CHARTER TOWNSHIP OF VAN BUREN
PLANNING COMMISSION AGENDA
Wednesday, April 27, 2022 – 5:30 PM
Van Buren Township Hall
46425 Tyler Road

ITEM #1: CASE 19-040 – CLOVER COMMUNITIES FINAL SITE PLAN REVIEW

TO: Van Buren Township Planning Commission
FROM: Dan Power– Director of Planning and Economic Development
RE: SPR 19-040 - Clover Development - Final Site Plan Review for Proposed Senior Housing Facility
DATE: April 22, 2022

Subject: VBT-19-040 Clover Communities Senior Housing / 8470 Belleville; Final Site Plan Review #3; Revised Site Plans Dated March 23, 2022.

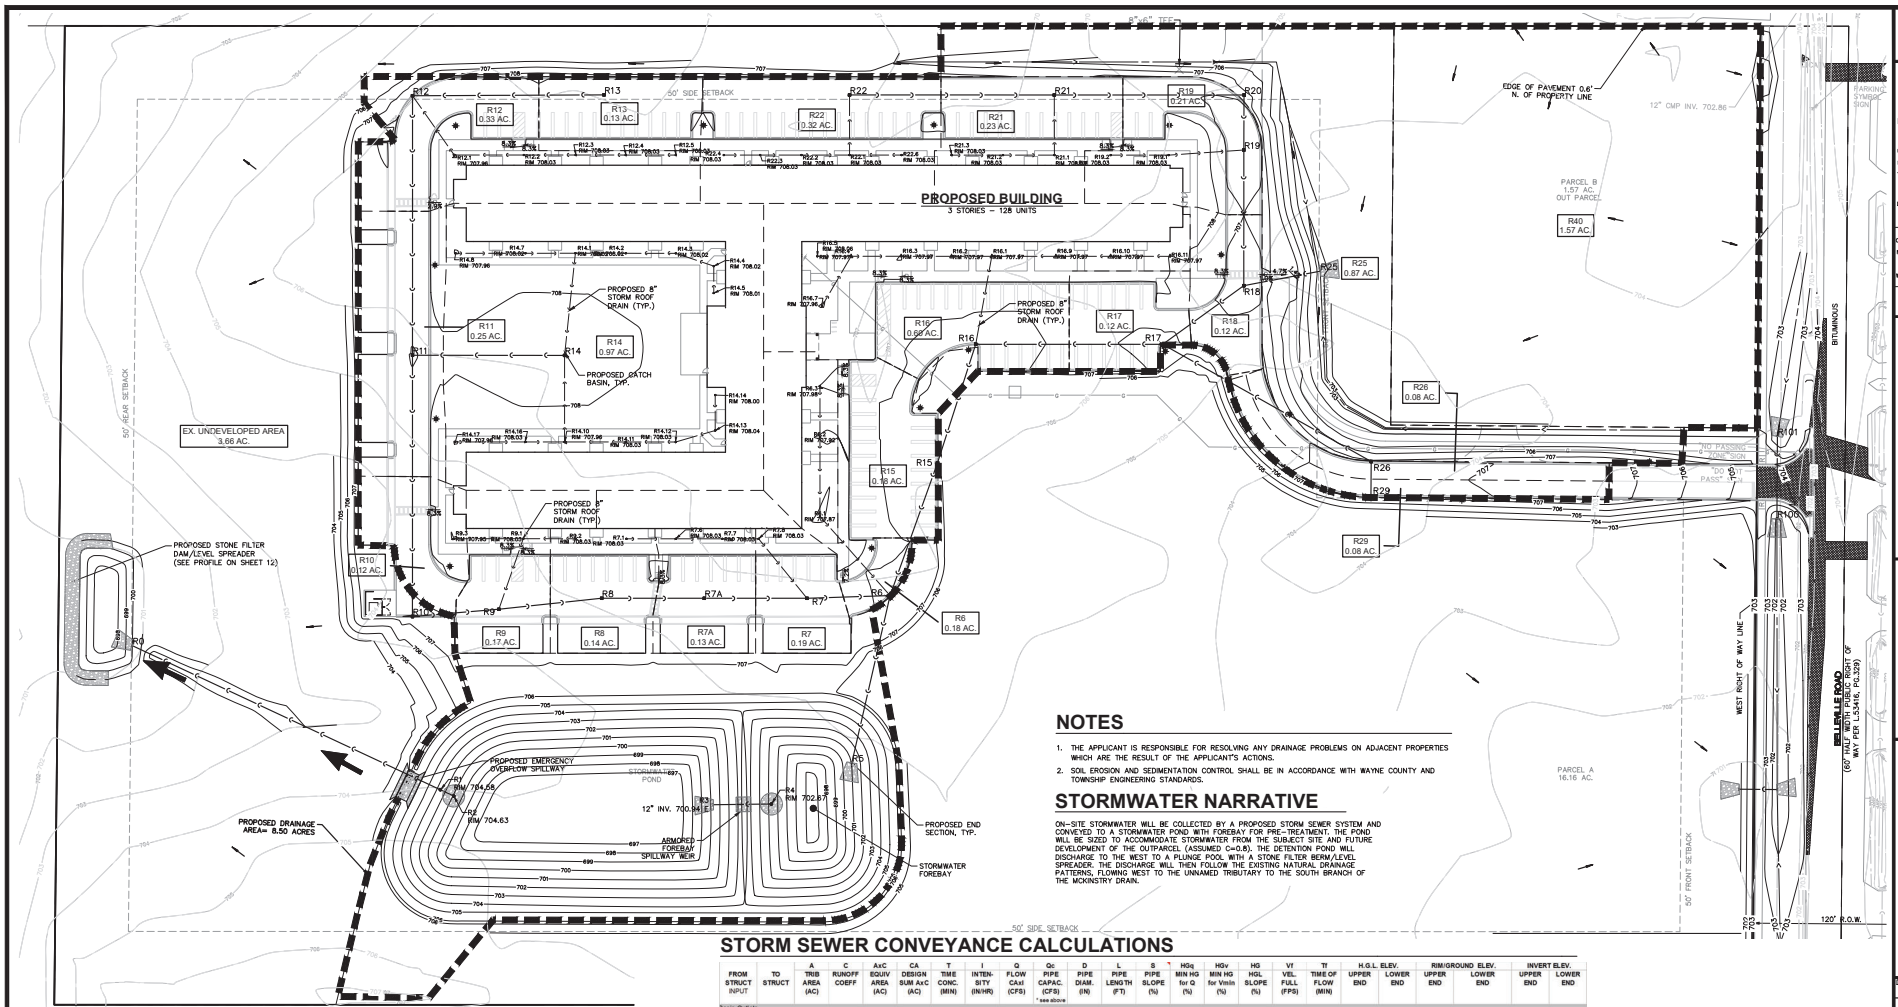
On sheet 08 the distance from the fire hydrant on the North side of the complex to the west side hydrant is 600 feet. The south side hydrant is approximately 510 feet front the west side hydrant.

~~The hydrant shown on the west side of the building needs to be moved to the Southwest corner, and an additional hydrant needs to be added to the Northwest corner. The hydrant spacing issue was noted in the last site plan review dated March 8th 2021~~

SCALE: 1"=40'
DRAWN BY: KS
CHECKED BY: JK
PROJECT MANAGER: JK
JOB #: 19003407
FILE CODE: FSP
SHEET NO. 16

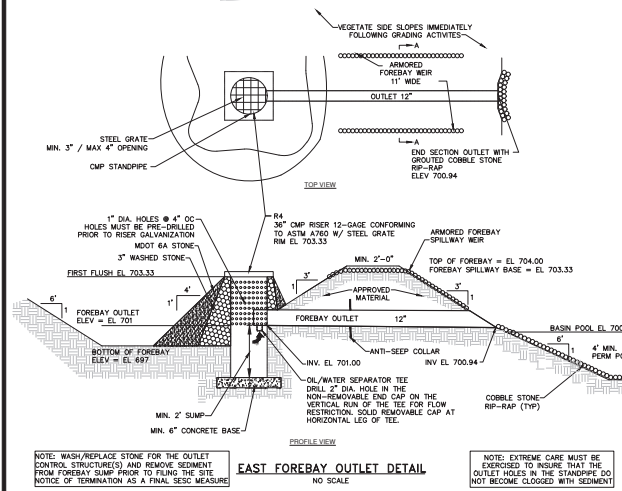
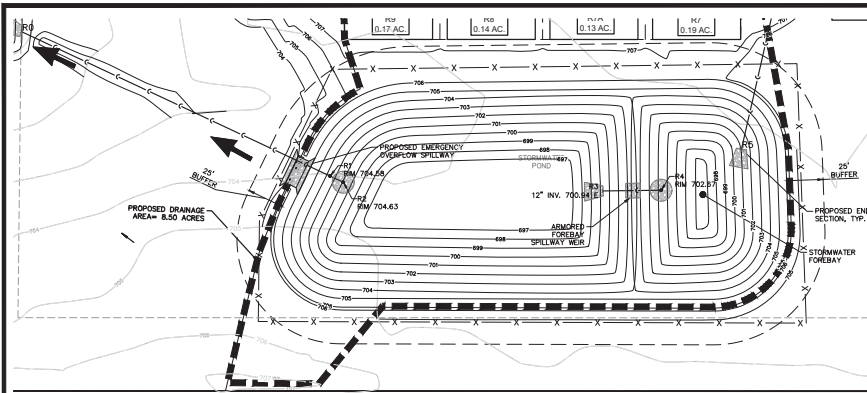
1. Fishbeck understands the review is still ongoing from the County, and thus, any changes or further requirements from them may result in a resubmittal of the plans.
2. An internal discussion is planned to discuss the required submittal information for the drainage across the property.
3. Storm structure R20 is labeled as a catch basin (CB), however, it appears to be located at the back of a curb with grade flowing away from the curb. Confirm and change to manhole if true.

DRAWN BY: KS
CHECKED BY: JK
PROJECT MANAGER: JK
JOB #: 19003407
FILE CODE: FSP
SHEET NO. 18

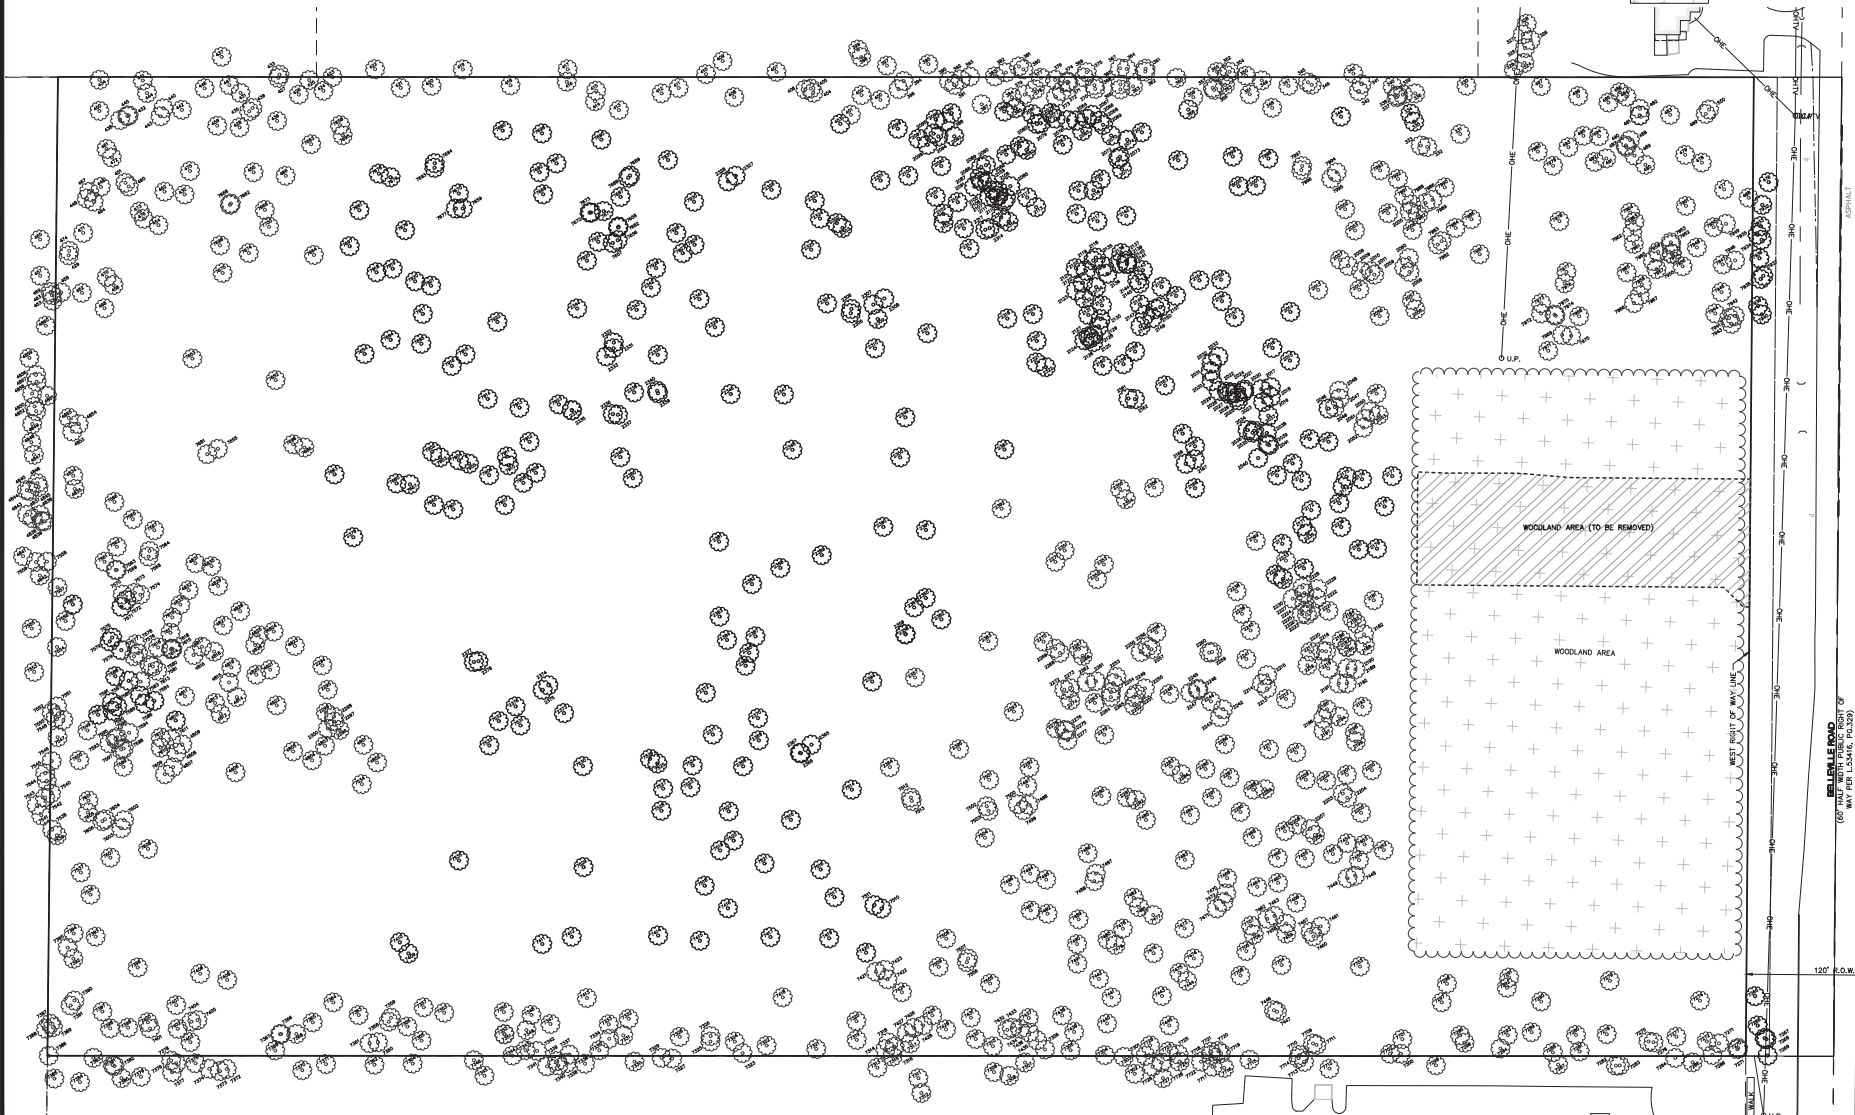
1. The applicant shall utilize “northbound (NB)” and “southbound (SB)” designation on the “Belleville Rd” signs to clarify which direction of Belleville Road is being detoured. These signs should be written as “NB Belleville Rd” or “SB Belleville Rd”.
